Lockheed Martin Utility Services, Inc.

TECHNICAL SAFETY REQUIREMENT
CLARIFICATION (TSRC) REQUEST FORM (Sheet 1)

Subject: UF₆ RELEASE DETECTION SYSTEM - DEFINITIONS OF CELL+UNIT BYPASS SECTIONS

TECHNICAL SAFETY REQUIREMENT CLARIFICATION**Paducah Gaseous Diffusion Plant****TSR Section: 2.4.4.1****TSR Title: UF₆ Release Detection System****Clarification Subject: UF₆ Release Detection System - Definition of Cell and Unit Bypass Sections**PGDP Document Control
Controlled Document

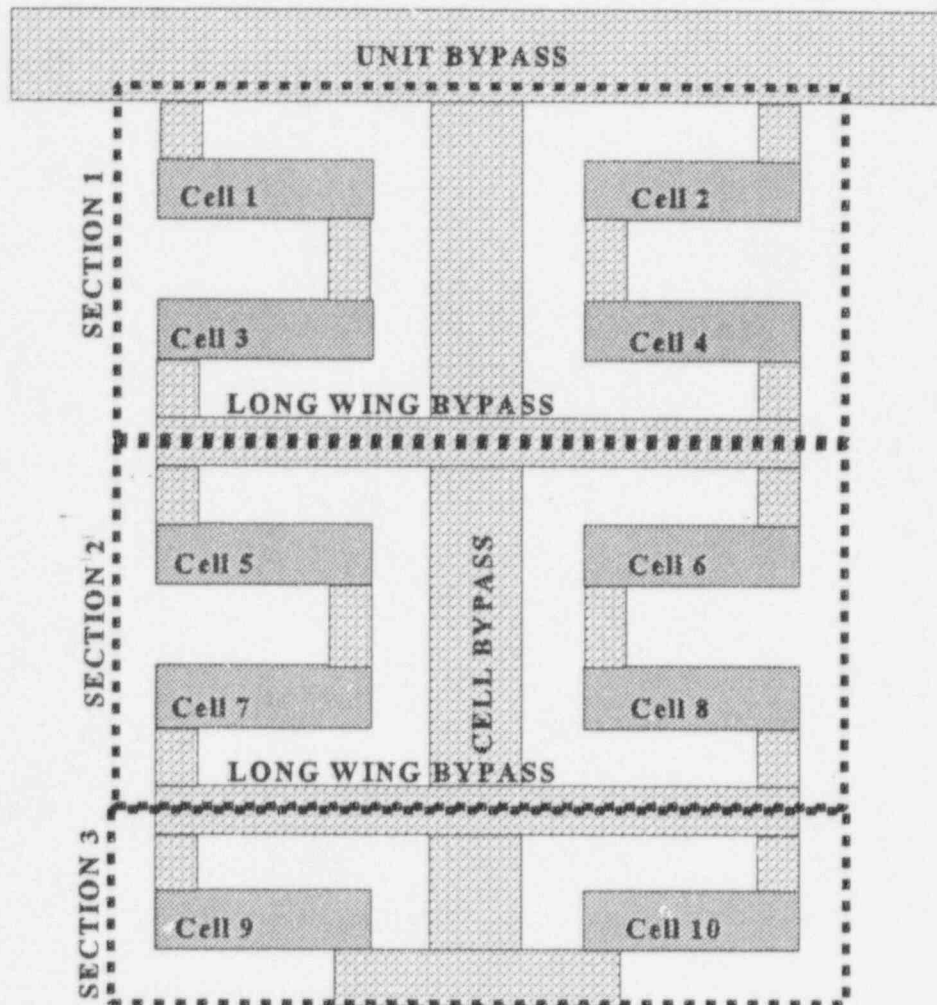
Unit bypass sections are defined as "that portion of the unit bypass between centerlines of adjacent units or from the centerline of the first or the last unit to the end of the housing." The centerline of a unit is the center of the cell bypass where it ties into the unit bypass. This divides the unit bypass into 5 sections in '00' buildings and 4 sections in '000' buildings.

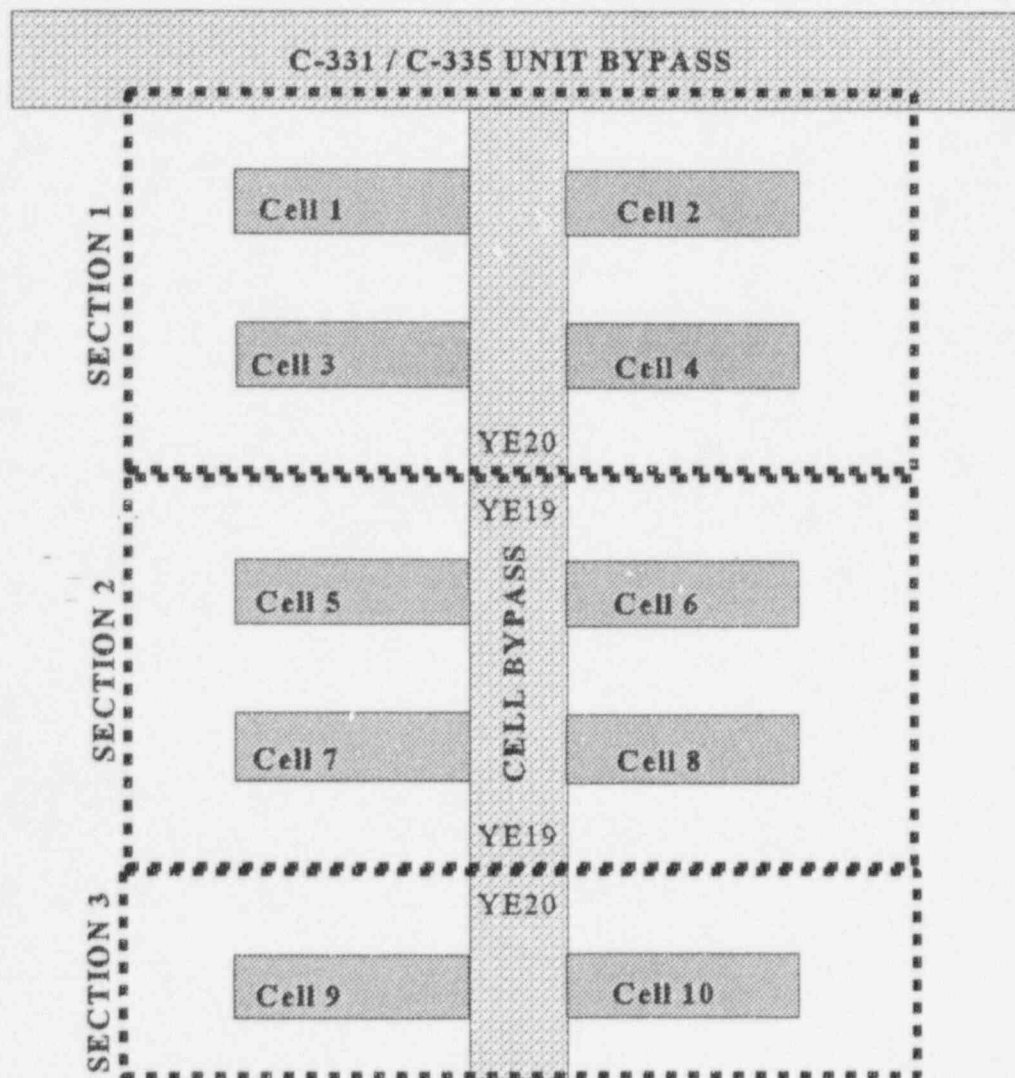
For '000' cell bypasses the sections should be defined as follows: the first section is defined as that section between the unit bypass and the long wing bypass between cells 3 and 5 (4 and 6); the second section is defined as that section between the long wing bypass between cells 3 and 5 (4 and 6) and the long wing bypass between cells 7 and 9 (8 and 10); the third section encompasses the area from the long wing bypass between cell 7 and 9 (8 and 10) and the end of the cell bypass housing. 3 of 4 detectors are required to be operable in section 3 rather than 3 of 6 for the other sections.

Cell Bypass Section Definitions for C-333 and C-337 - '000' Buildings		
Three detectors in each of the following sections must be operable or LCO action steps shall be taken:		
Section 1	Section 2	Section3
U-2-YE-16	U-6-YE-16	U-9-YE-16
U-2-YE-17	U-6-YE-17	U-9-YE-17
U-3-YE-16	U-7-YE-16	U-10-YE-16
U-3-YE-17	U-7-YE-17	U-11-YE-17
U-4-YE-16	U-8-YE-16	
U-4-YE-17	U-8-YE-17	
U-C-YE-XX - 'U' indicates unit number; 'C' indicates cell number; 'XX' indicates head designation
